**RE: Vacant Land Evaluation in Vevay Township, Section 27, 1514 Rolfe Road Mason, MI  
48854 Parcel 33-10-10-27-200-022, Application 4-28-17-104**

# SOIL EVALUATION DATA SHEET

Application # 4-28-17-104 Township: VeVay  
Section: 27 Road Location: W of Ives., N of Rolfe. 1514 Rolfe (parent)  
Subdivision: M + B. Lot # — Side of Road: —  
Parcel # 33- 10-10-27-200-022 Parcel Size: 13.81 Potential Splits: 2  
(1514 Rolfe - Parent parcel) + 13.49 Acres

## Plot Plan

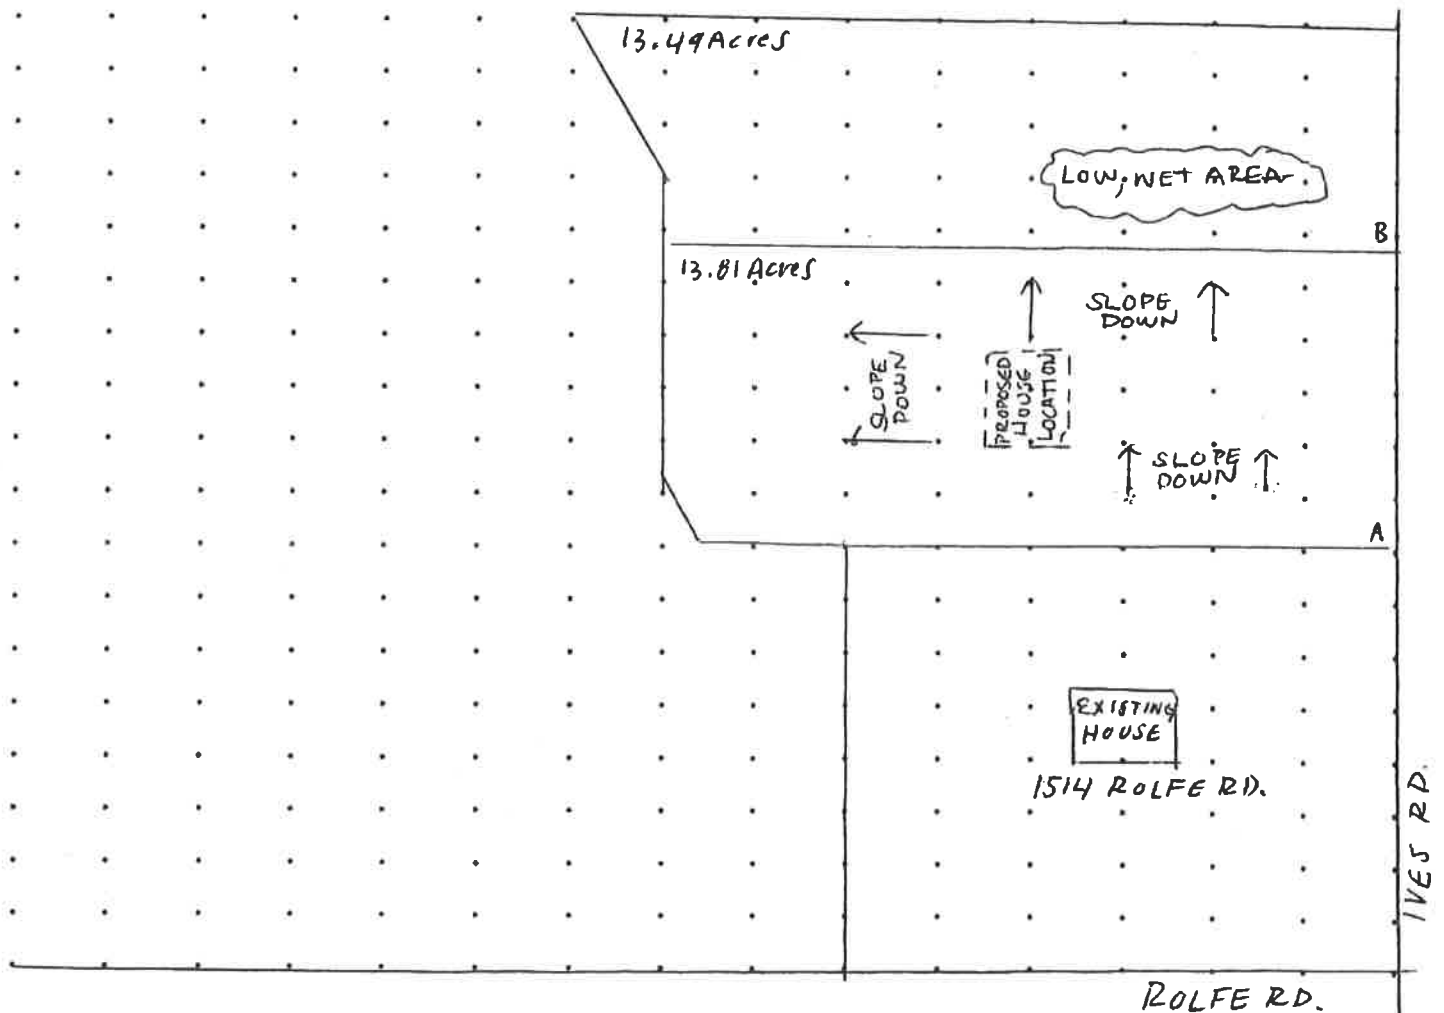
Test #	1	2	3
Type of Test	BH	BH	BH
Depth	60"	60"	60"
Top Soil Texture	0-12"-LS TS	0-10"-LS TS	0-12"-LS TS
Layer 1	12-16"-LS (NMT)	10-20"-LS (NMT)	12-20"-SCL (NMT)
Layer 2	16-60"-LS (MT) Saturated	20-60"-LS (MT)	dull, wet 20-60"-SCL (MT)
Layer 3	* VERY MT @ 4', WL @ 4.5'	* VERY MT @ 5', WL @ 5'	+ VERY saturated, gray, WL @ 4.5'
Layer 4			
Layer 5			
Water level	For B (13.49 Acres) ↘		
Test #	4	5	
Type of Test	BH	BH	
Depth	54"	54"	
Top Soil Texture	0-10"-LS TS (dark)	0-10"-LS TS (dark)	
Layer 1	10-54"-LS, gray, saturated (MT) w/ gravel	10-15"-SCL (bright)	
Layer 2		15-54"-SCL (MT) saturated. w/ gravel	
Layer 3			
Layer 4	* WL @ 4.5'	* WL @ 4.5', MT heavily.	
Layer 5			
Water level

Comments: An engineered field is required for both splits.
